DOCKET
09-AFC-8

Subject: **GENESIS SOLAR, LLC's DATA RESPONSES TO CURE'S DATA
REQUEST SET 1 (1-66)
DOCKET NO. (09-AFC-8)**

Enclosed for filing with the California Energy Commission is the original copy of
**GENESIS SOLAR, LLC's DATA RESPONSES TO CURE'S DATA REQUEST SET 1A
(1-66)**, for the Genesis Solar Energy Project (09-AFC-8).

AVIAN POINT COUNT LOCATIONS IN RELATION TO VEGETATION TYPES

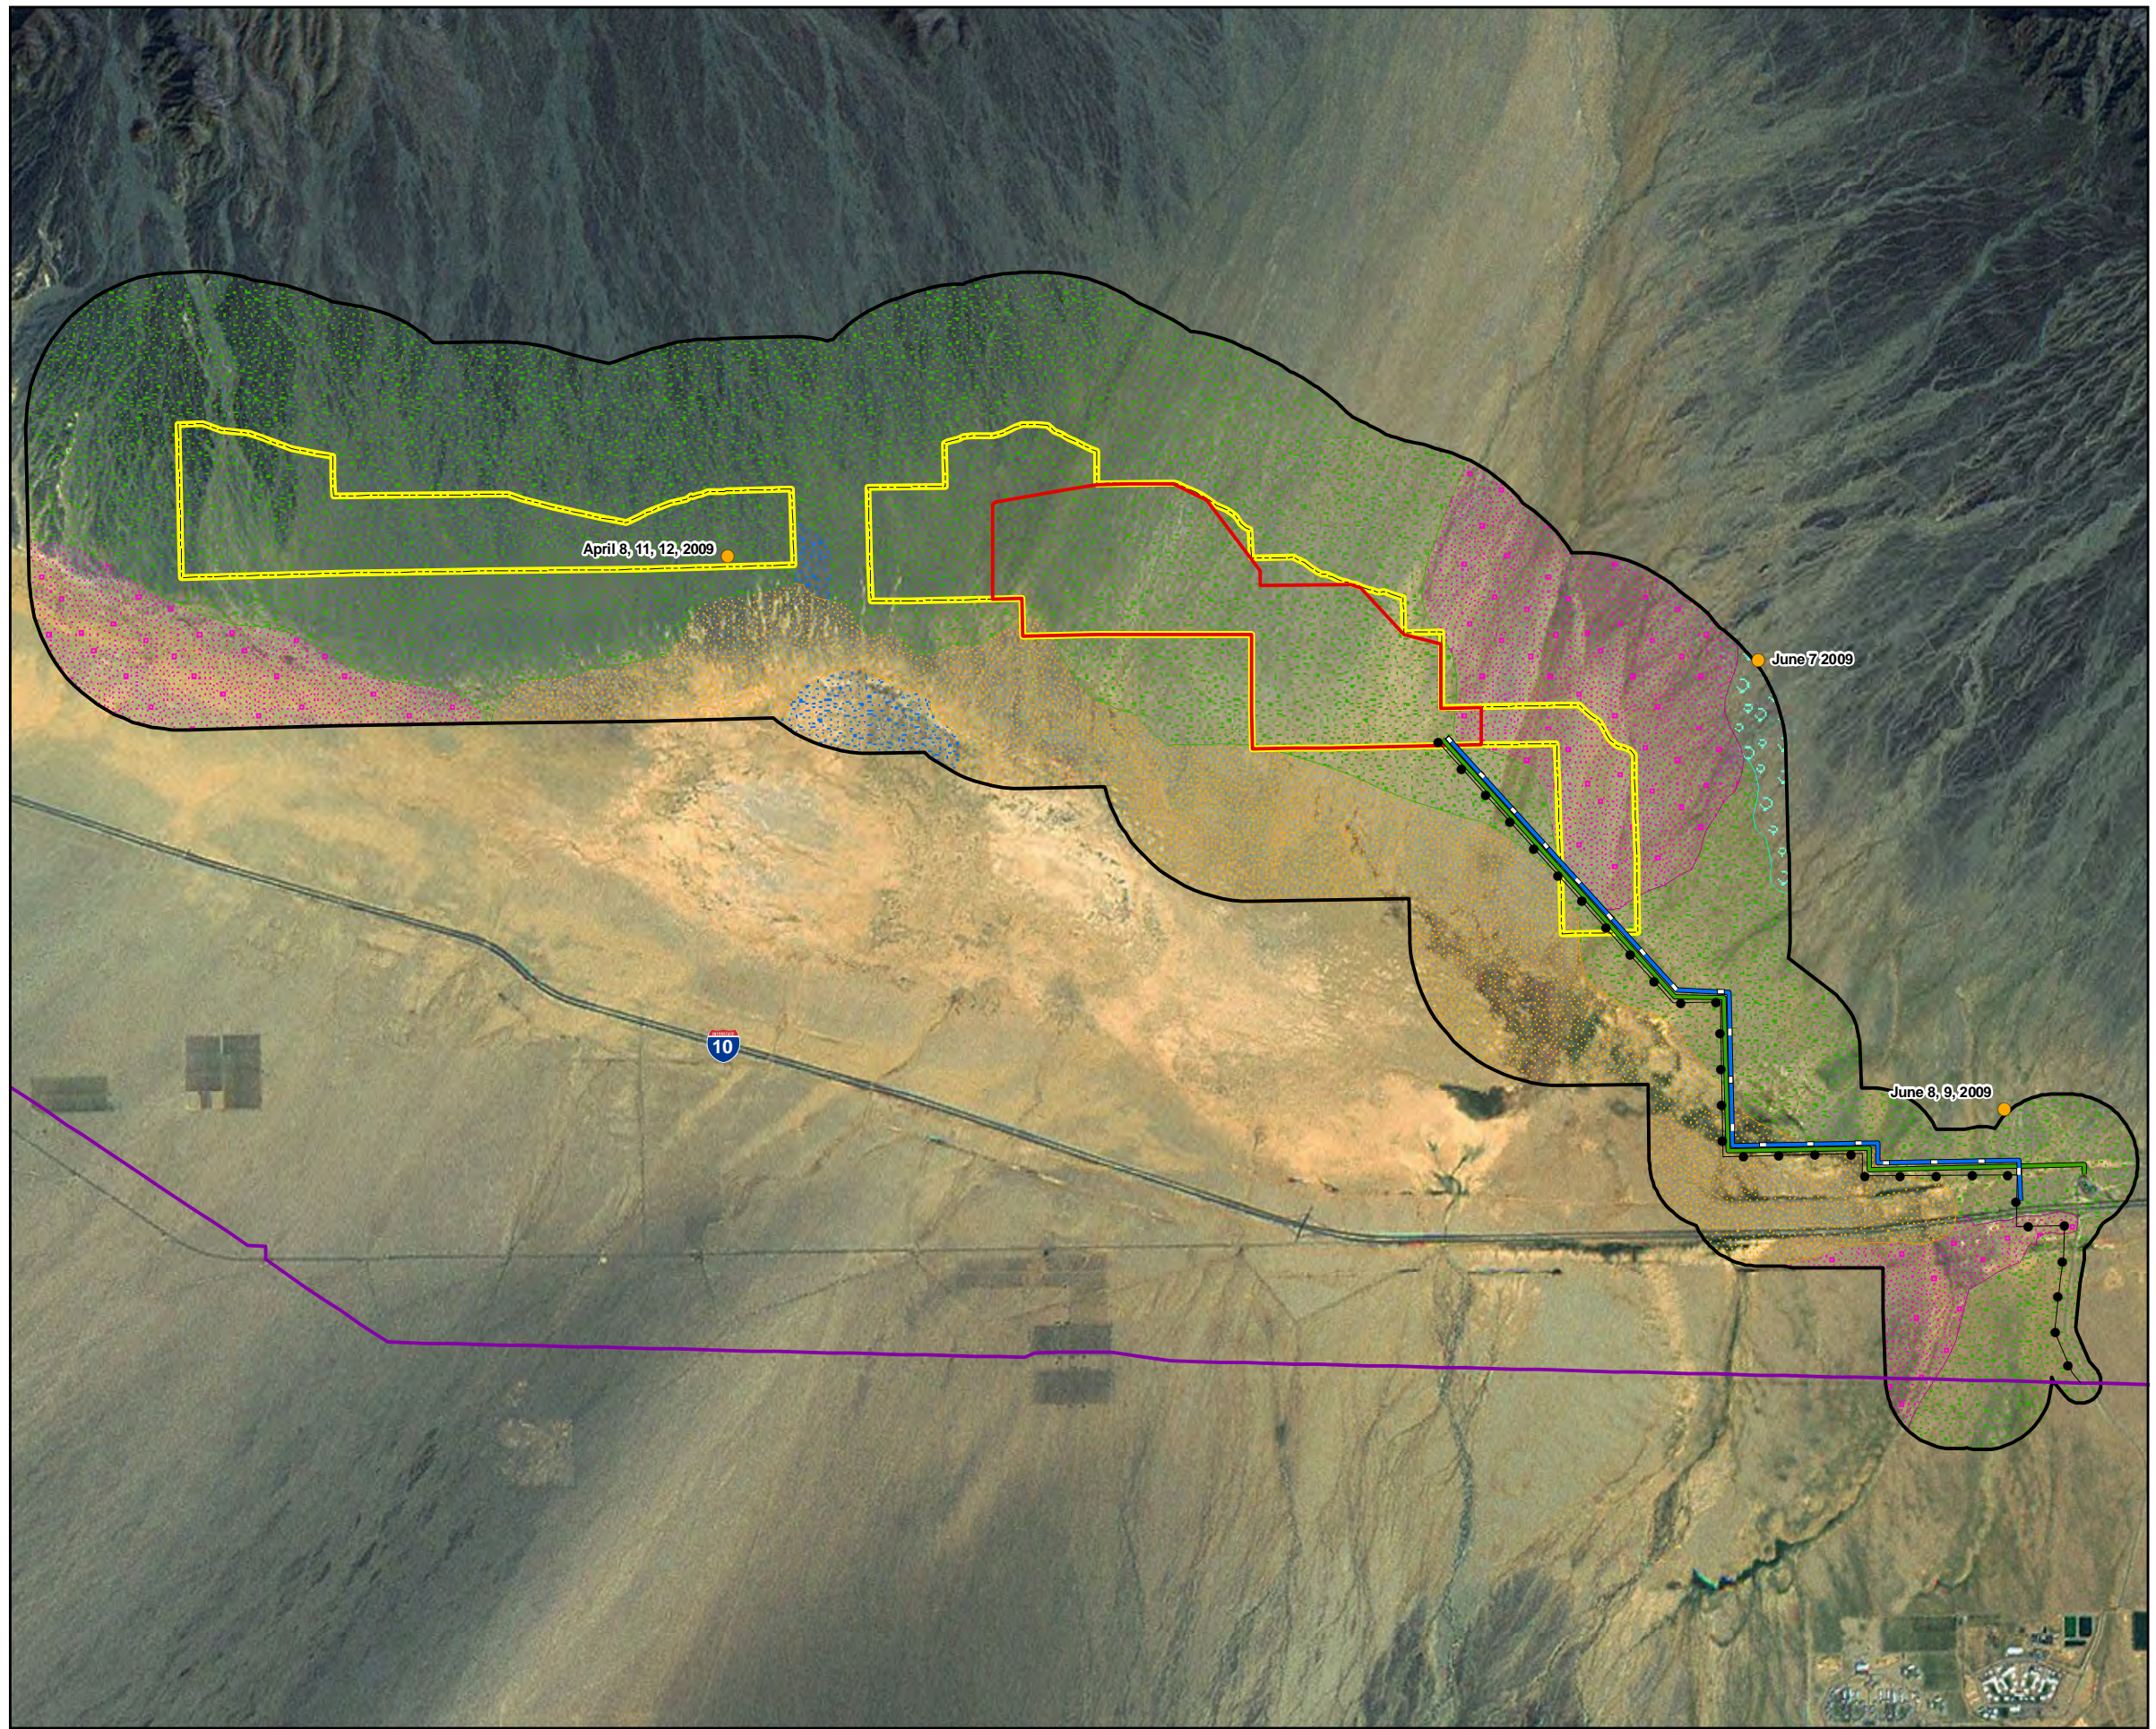
Please provide a copy of the protocol that the Applicant used for avian point-count surveys.

Please provide the Applicant's objectives for the avian surveys (e.g., whether they were intended to characterize species richness, abundance, and composition of the birds that will be impacted by the Project).

Response:

Response:

ENLARGED AREA

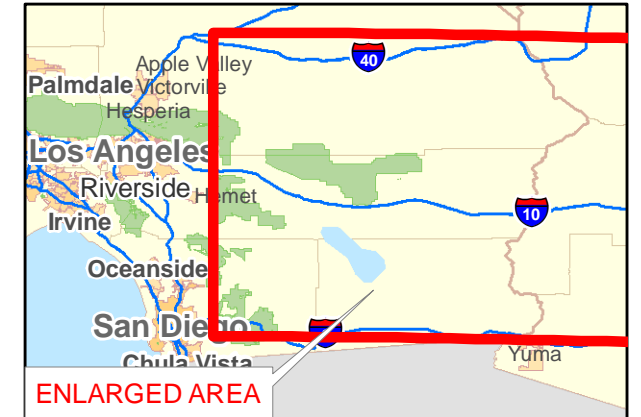
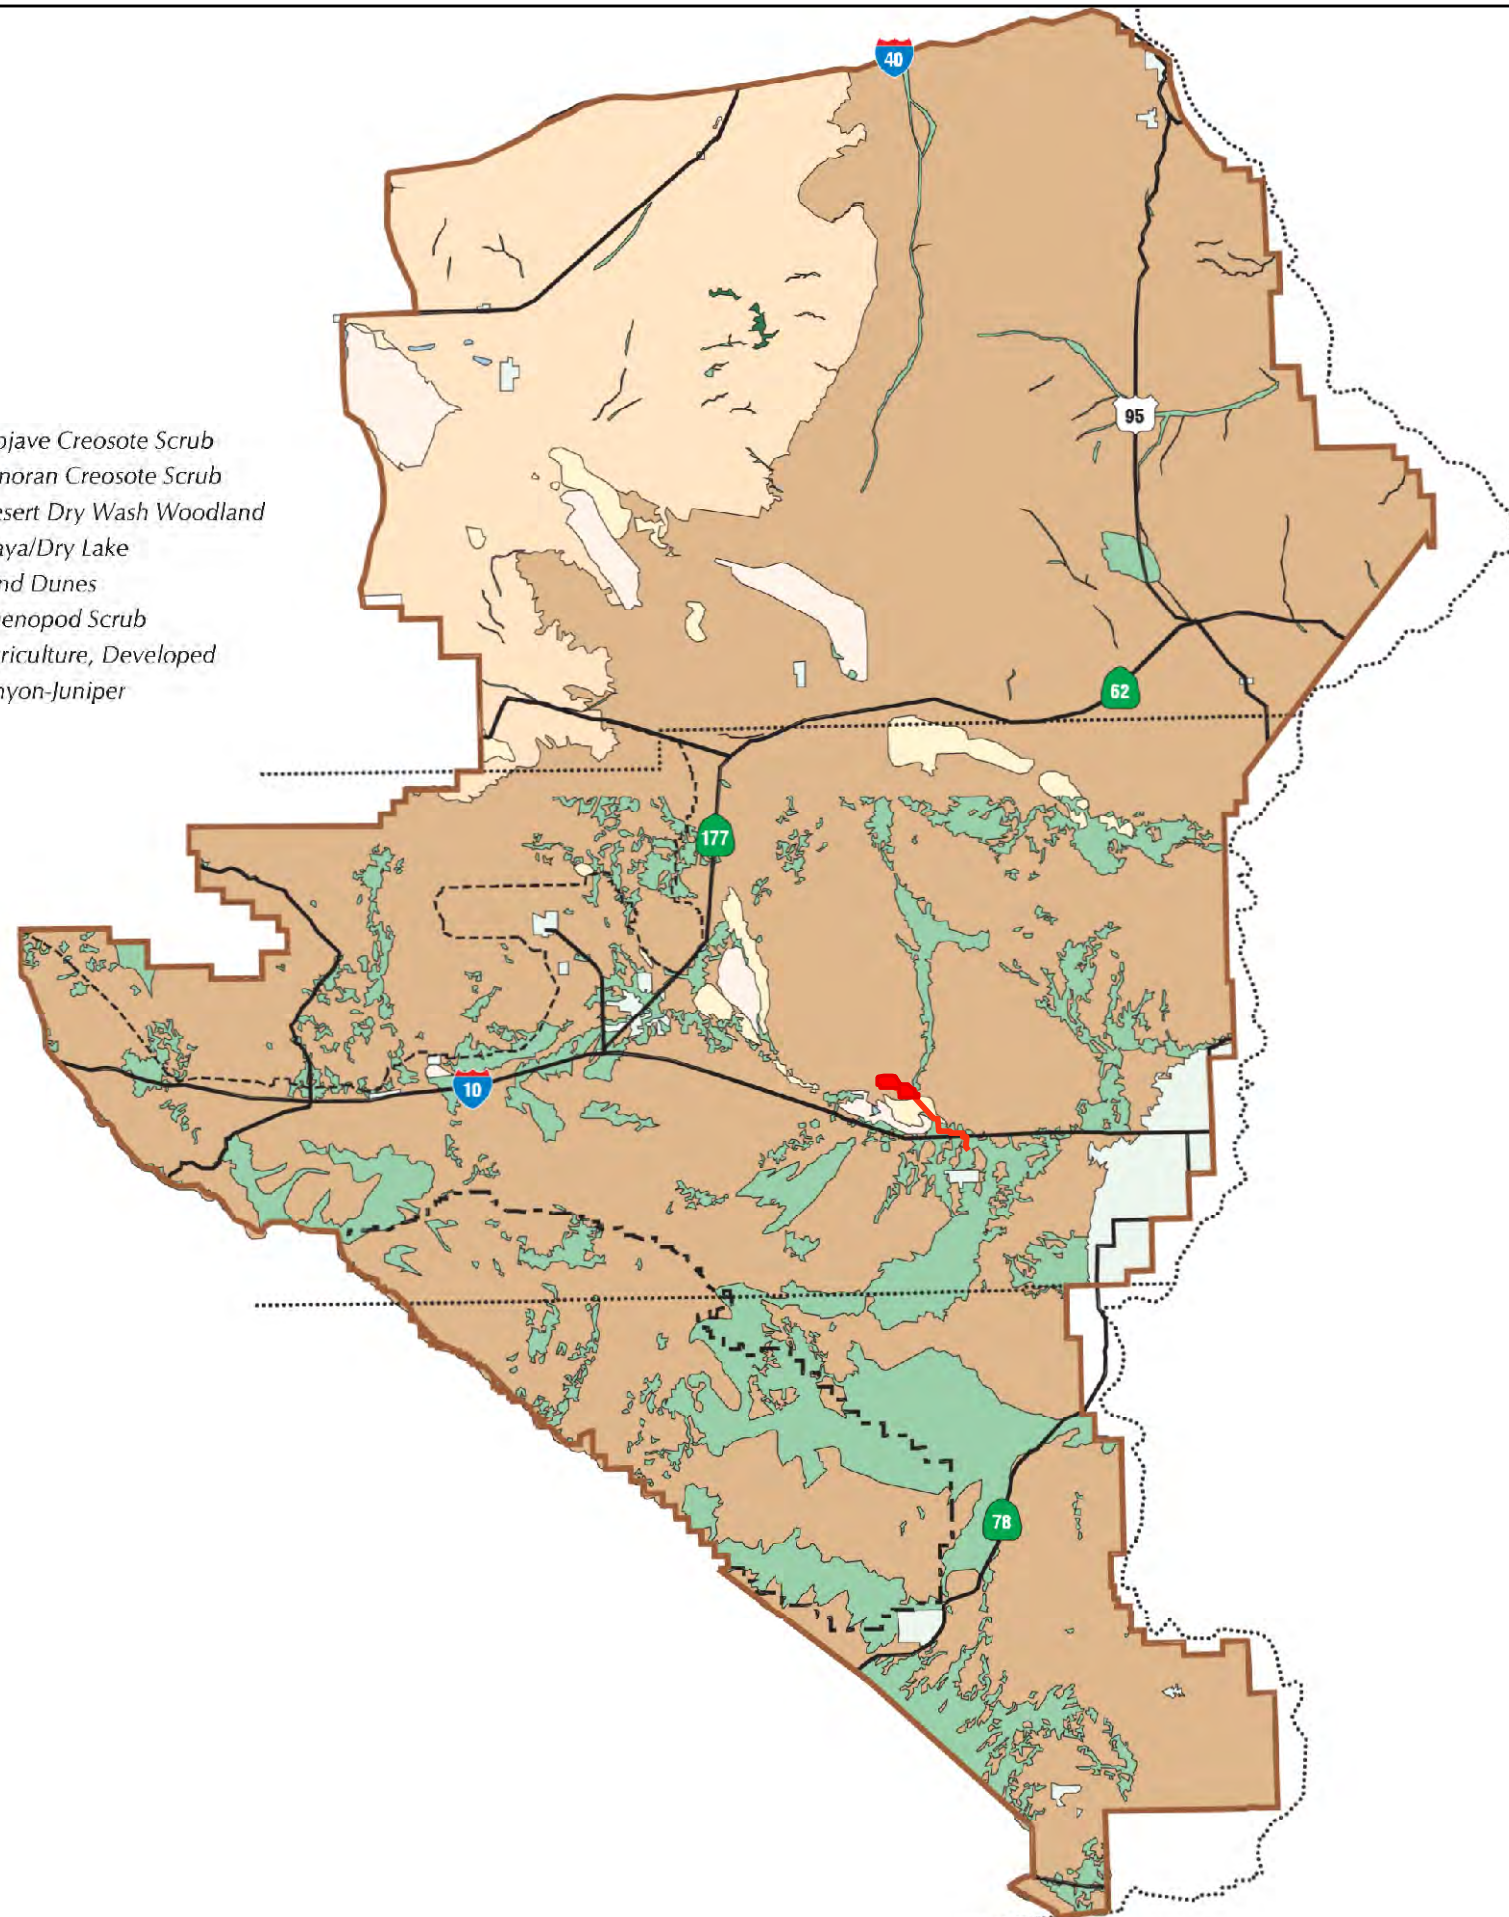
Please provide the methods that were used for small mammal trapping, including personnel, trap hours, trap configuration, trap size, and bait used.

Please provide the results of the small mammal trapping surveys, including a list of all wildlife species that were captured.

Two major areas, representing the habitats in the Project vicinity, were trapped (see attached figure, Small Mammal Trapping Locations). Each area was trapped for 300 trap-nights using 100, 15-inch Sherman live-traps, set in a 4 x 25 configuration (four lines of 25 traps each), with lines spaced 25 m apart and traps spaced at 15 m. Lines were set across the slope. Traps were opened approximately one hour before dark and baited with a mixture of crimped oats, rolled oats, bird seed, and peanut butter. Traps were checked near dawn the following morning. Data gathered included: species, age, gender, reproductive condition, mass, if a recapture (pelage clipping), the number of sprung traps, weather (ambient temperature, wind speed, cloud cover) and moon phase the previous night, and presence of ants. Two biologists with 10,000s of trap-nights each ran the trap lines (Woodard and Karl; see table in response to Item 18, above), accompanied by biologists Emily Festger and Peggy Wood

Figure 3 of the *Biological Resources Technical Report Biological Resources Technical Report* (TetraTech and Karl 2009) identifies the habitats on the ROW and surrounding area; Section 5.2 describes those habitats. A map is attached with the trapping grid locations overlain on the vegetation map.

* See Attached Figure for Trap Locations

**NECO MAP 3-3
IN RELATION TO
PROJECT AREA**

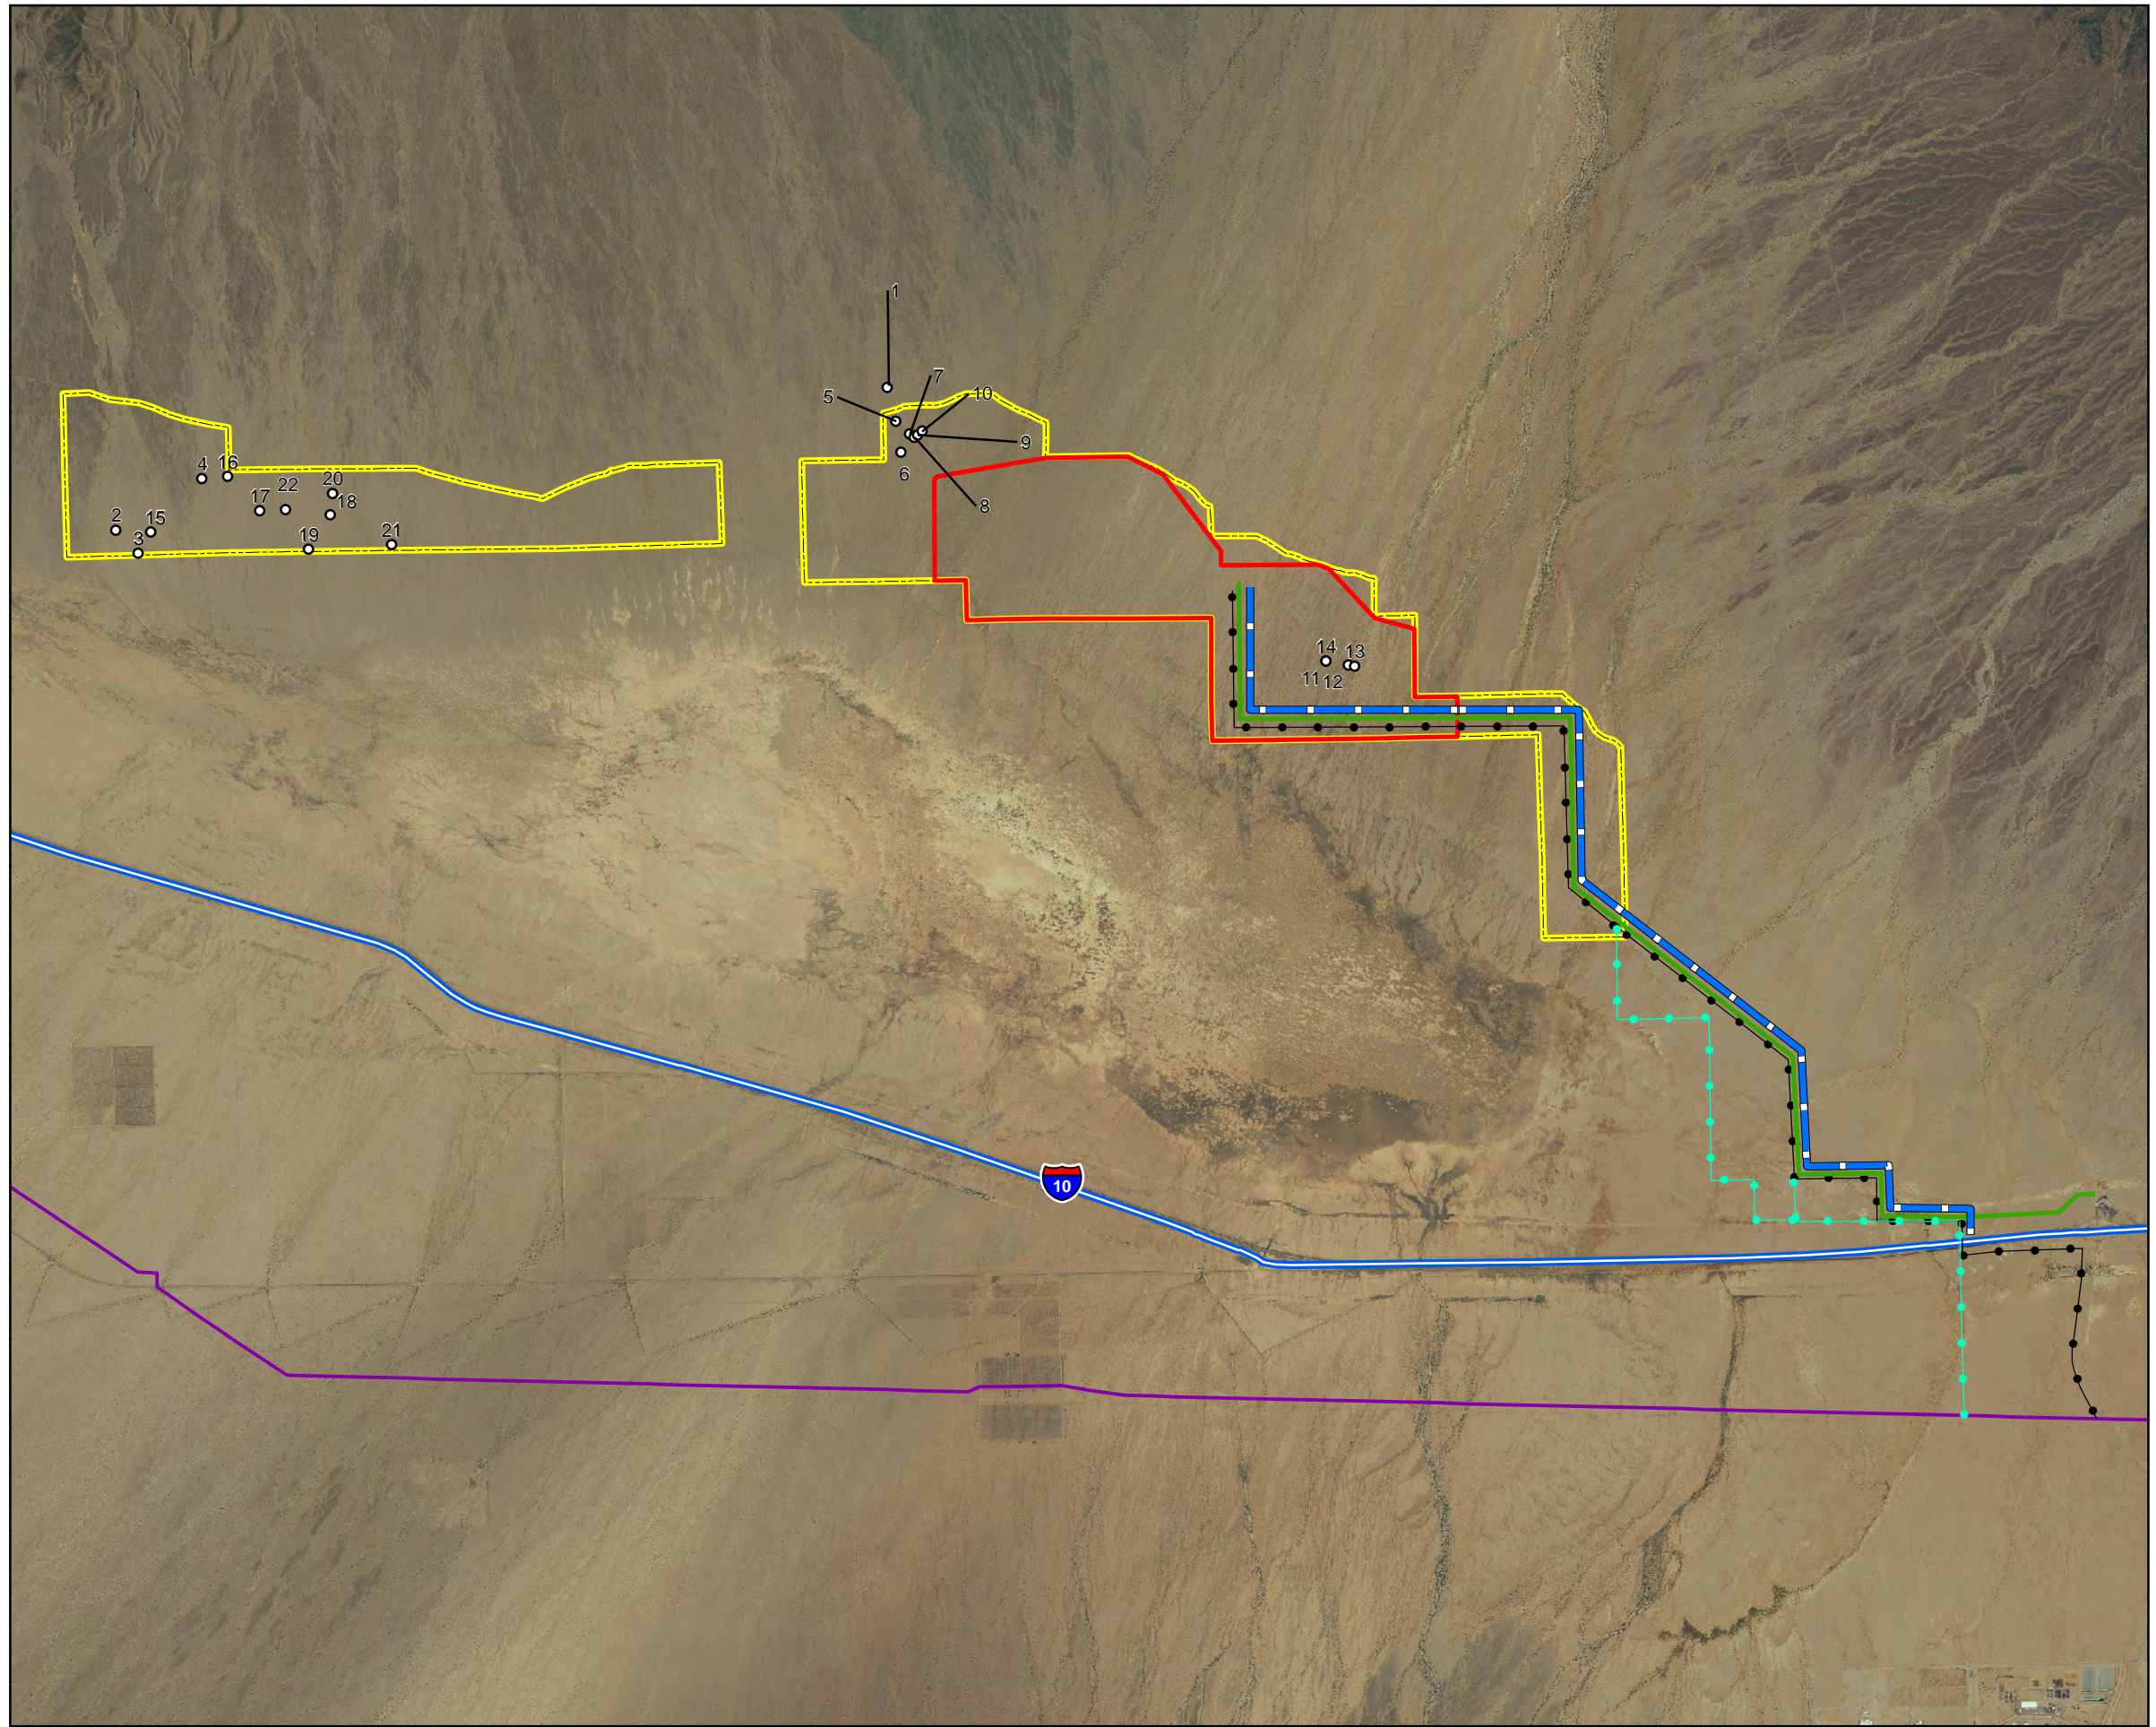
Please identify the Project boundaries (including linear facilities) in relation to the vegetation communities depicted on Map 3-3 of the NECO Plan.

See attached figure for the Plant Site and Linear Facilities in relation to the NECO Plan's Map 3-3. There are also two attached figures that show the vegetation communities that were based on the actual pedestrian field surveys. These field surveys are a more accurate representation of the vegetation communities present within the Project Area than the broad NECO Plan Map.
